Browns Ferry Nuclear Plant, Units 1, 2, and 3
Renewed Facility Operating License Nos. DPR-33, DPR--52, and DPR-68
NRC Docket Nos. 50-259, 50-260, and 50-296

Subject: **Completion of Required Action by NRC Order EA-12-051, Reliable Spent Fuel Pool Instrumentation**

RESPONSES TO NRC REQUESTS FOR ADDITIONAL INFORMATION

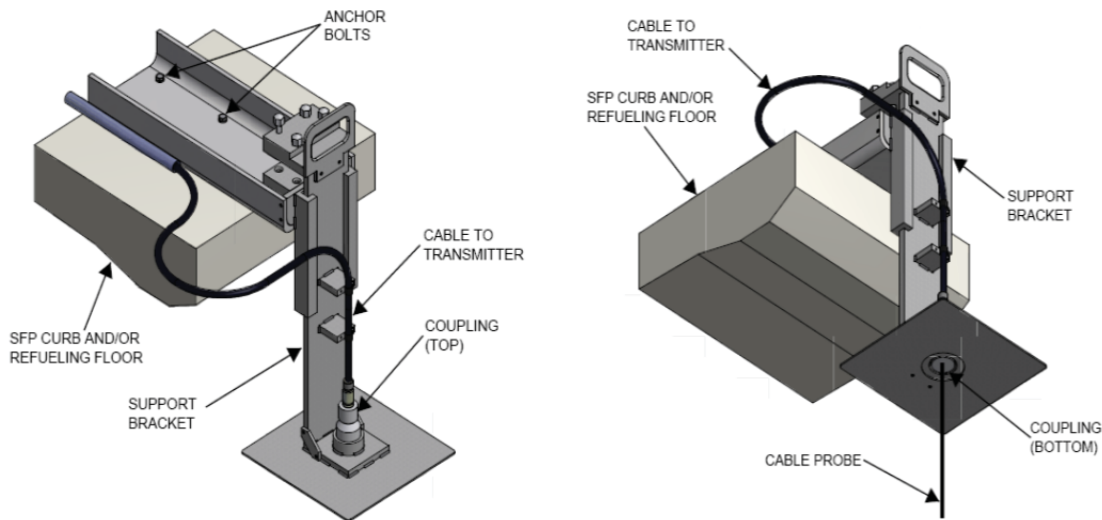
- b) A description of the manner in which the level probe (and stilling well, if appropriate) will be attached to the refueling floor and/or other support structures for each planned point of attachment of the probe assembly. Indicate in a schematic the portions of the level probe that will serve as points of attachment for mechanical/mounting or electrical connections.*
- c) A description of the manner by which the mechanical connections will attach the level instrument to permanent SFP structures so as to support the level probe assembly.*

- b) The level sensor cable assembly is suspended from a support bracket, which is secured to the refueling floor and/or spent fuel pool curb using concrete anchor bolts. The level sensor cable suspended in the SFP is attached to a threaded coupling, which is secured to a support bracket. The cable leading to the transmitter is also attached to the threaded coupling. See Attachment 1, Item 12. The generic illustrations below depict these attachments.

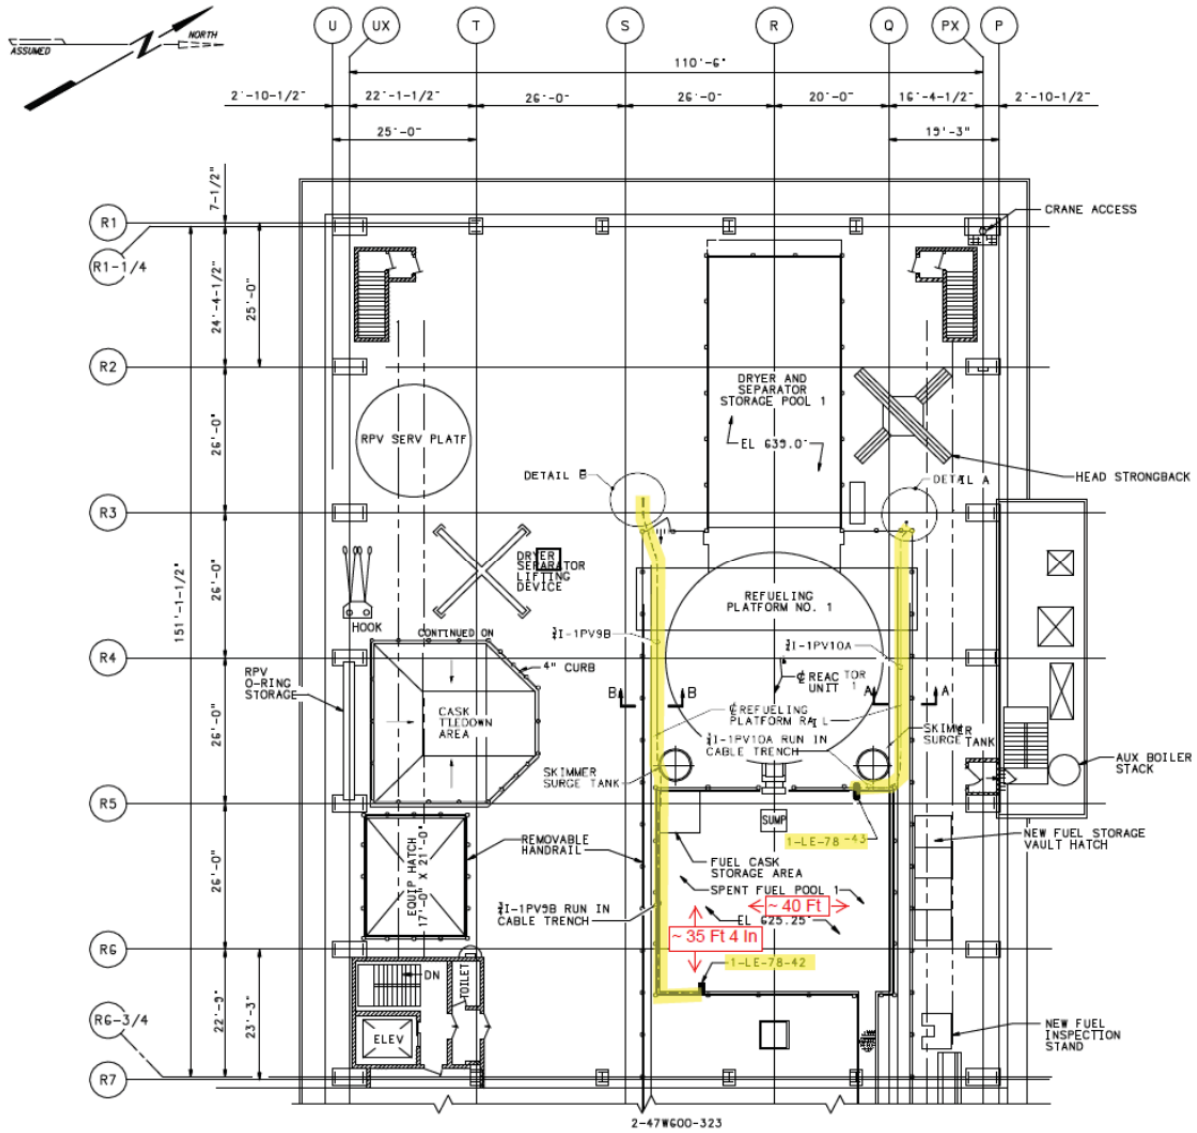
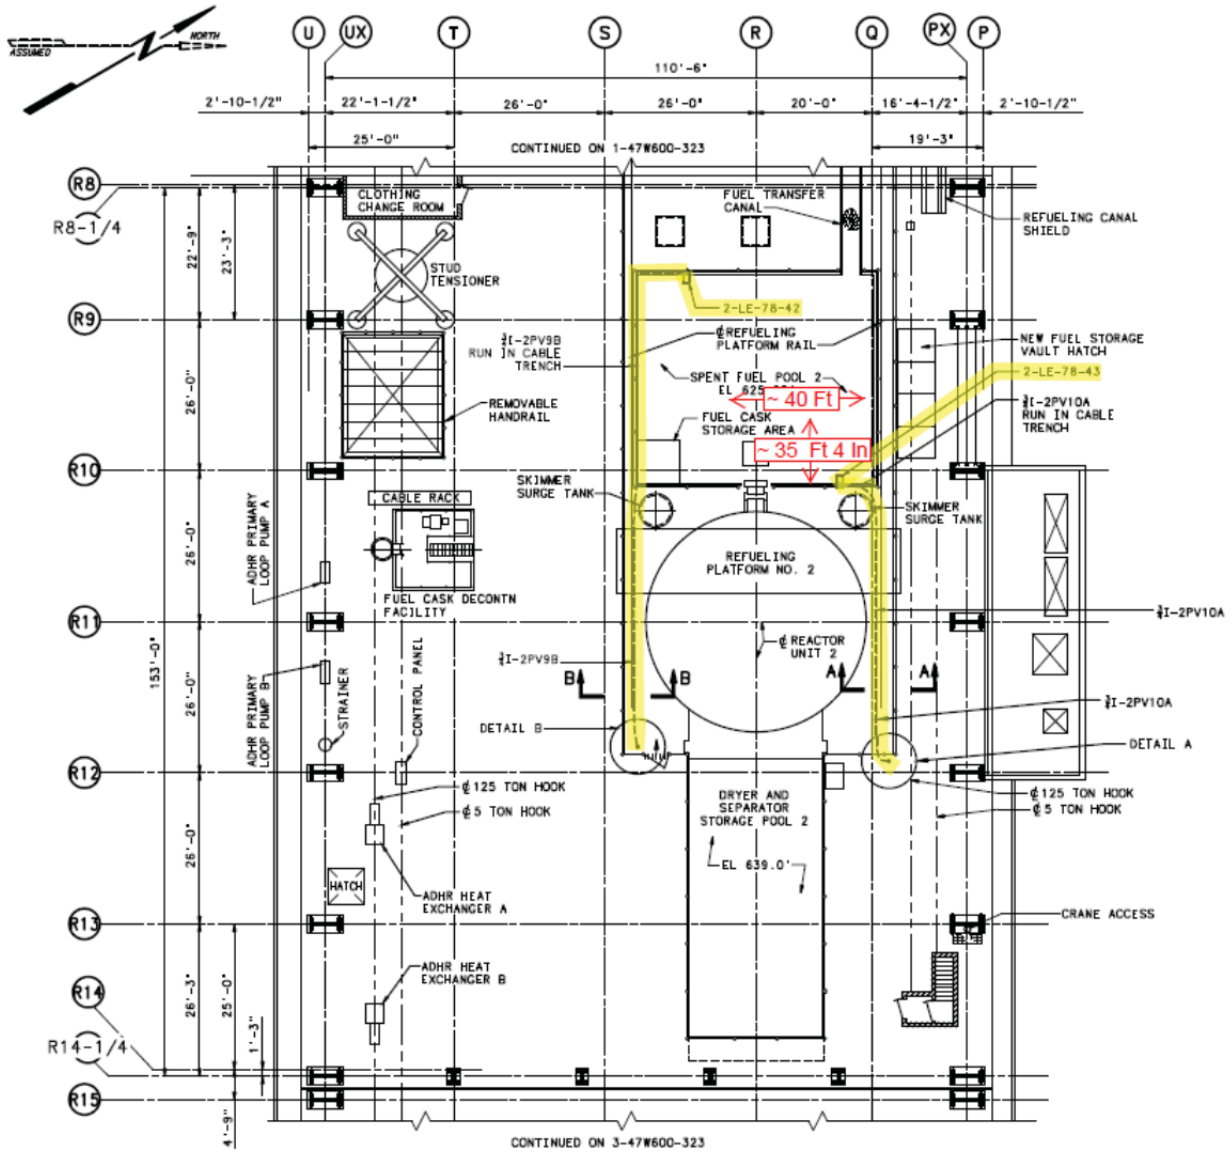
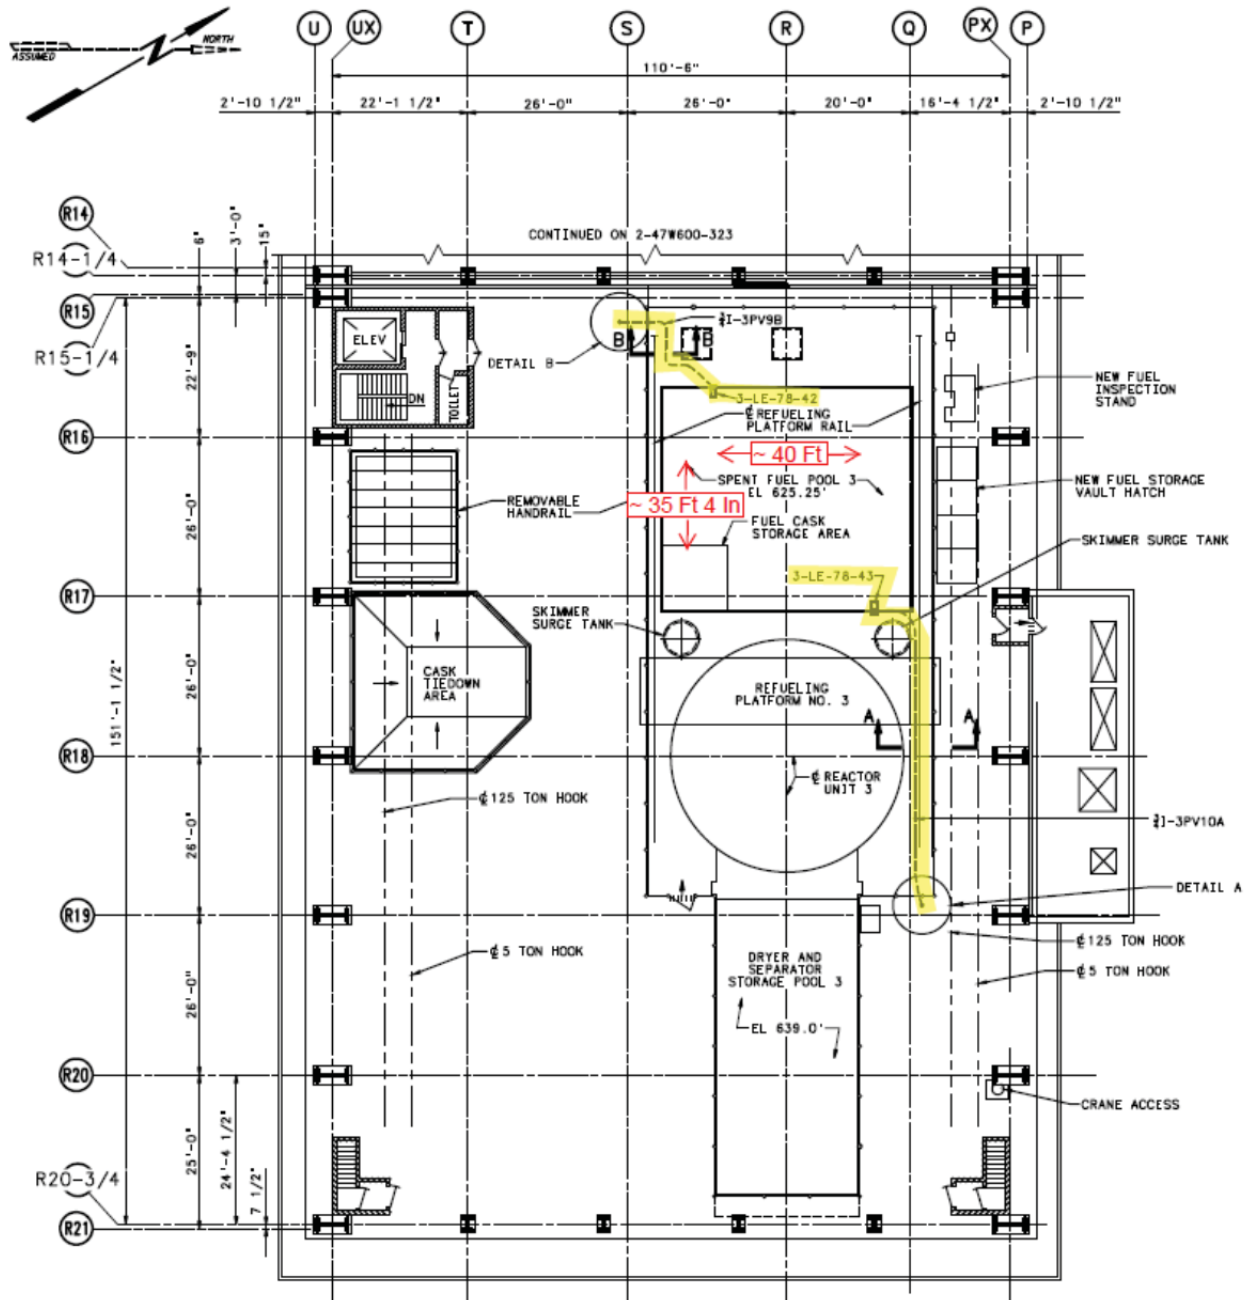
Please provide a clearly labeled sketch or marked-up plant drawing of the plan view of the SFP area, depicting the SFP inside dimensions, the planned locations/placement of the primary and back-up SFP level sensor, and the proposed routing of the cables that will extend from the sensors toward the location of the read-out/display device.

See attached sketches, pages E2-16 - E2-19, for plan view of the SFP area, depicting the requested information.
